Record of Letter Ballot Review by TC Chapter for Procedural Review

Global Technical Committee: **Liquid Chemicals**

Document Number	Document Title
7086A	Revision to SEMI F61–0521, Guide for Design and Operation of a Semiconductor Ultrapure Water System, with title change to: Guide for Design, Construction, Installation, and Operation of a Semiconductor Ultrapure Water System

Negative 42

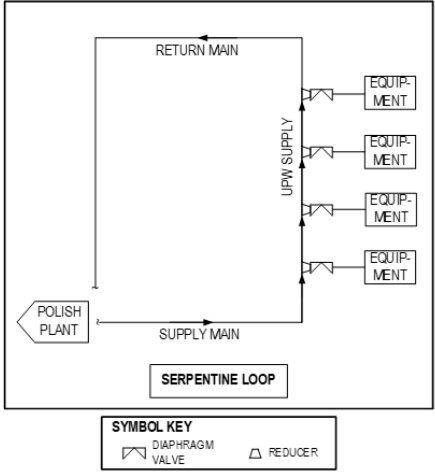
Negative	Referenced § / ¶	*TF/TC Chapter to fill in, including text in the ballot if necessary.	
	Negative Text	A3-2.6 Typical Raw Water Quality Analytical Profile — Table A3-1 is an example of a complete analytical profile that should be completed for each source of raw water to a UPW system. SG042: For this to be "an example of a complete analytical profile" of a "Typical raw water" sample, it must contain typical values. Without values, this is a form listing analytes the units in which they are to be reported. Either provide data or relabel this table.	
	Withdrawal (check one)	<input checked="" type="checkbox"/>	No Negative withdrawal made by Voter. GO TO "Related" subsection
Related	Motion and Reason (check one)	<input checked="" type="checkbox"/>	'Related' is mutually agreed upon. (Needs no motion.) GO TO "Persuasive" subsection
	Motion and Reason	<input checked="" type="checkbox"/>	Negative is related and not persuasive. (Needs ≥2/3 votes to pass.)

Persuasive	(check one)		Reason	The text is technically correct and the TF believes it is clear as-written.
	Motion by/ 2 nd by	By: Lindsey Sullivan / FTD Solutions Second: Soren Allebes / Georg Fischer		
	Discussion	None		
	Result of Vote (check one)	14 Y 0 N; Motion passed.		
Significant		X	90% ≤ [Negative is related and not persuasive.]	GO TO “Not Significant Finding Option” subsection
	This option can be used only “if the TC Chapter finds a Negative not persuasive by a vote equal to or greater than 90% of the persons voting on the action”. (Regulations ¶ 9.6.1.4.5.2)			
	Use of “Not significant finding option” (check one)	X	It is mutually agreed upon to term the Negative “not significant”.	GO TO “Final” subsection → (D)
Final	(check if applicable)	X	(D)	Not significant (counted under j in disposition)
